From: Schmidt, Eric <Eric.Schmidt@aecom.com>
Sent: Wednesday, July 1, 2020 12:24 PM
To: Richard, Philip E - DNR
Cc: Pooler, Cary; 'NAVE, BRADLEY S'; Saari, Christopher A - DNR
Subject: RE: Barksdale - COVID-19 Impacts Addendum Letter
Attachments: Use Area PAT Stockpile Photos_06.29.2020.pdf

The WDNR has reviewed the addendum letter for the Former Dupont Barksdale Works Site dated May 18, 2020. This email serves as an approval to your exemption request under NR 718.05 with the following considerations:

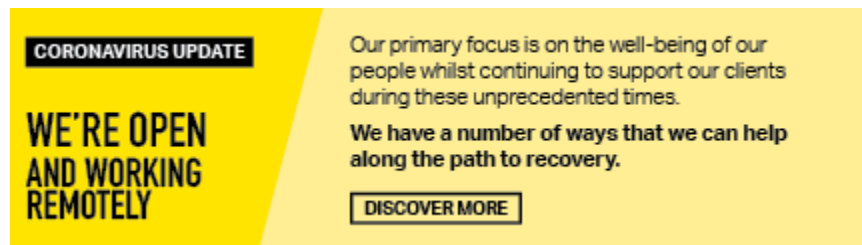
-Is there any water run-off from the material? It didn't appear there was from the picture, but it didn't show the entire area. Can you send a couple more pictures that show more of an overview of the area?

1. No, there is no free liquid running off the material. Additional pictures are attached.
2. Yes, we will monitor the stockpile as it dries and send you an update and corresponding pictures weekly.

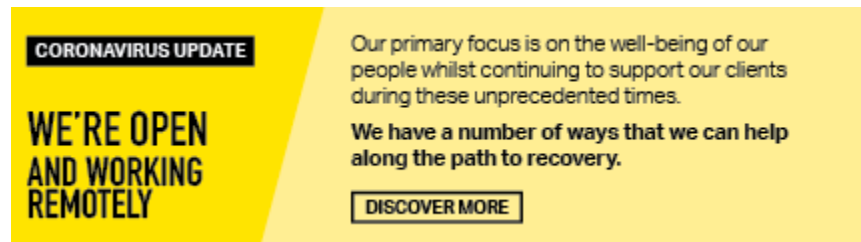
The material we are receiving is too wet to meet the requirement in NR718.05 that stockpiled soil be "...sloped and graded to eliminate depressions in the surface..." (see attached photos). We are requesting WDNR approval to leave the material uncovered until it is dry enough to be graded. A cover would be applied at that point.

You may leave the material uncovered until it is dry enough to work with.
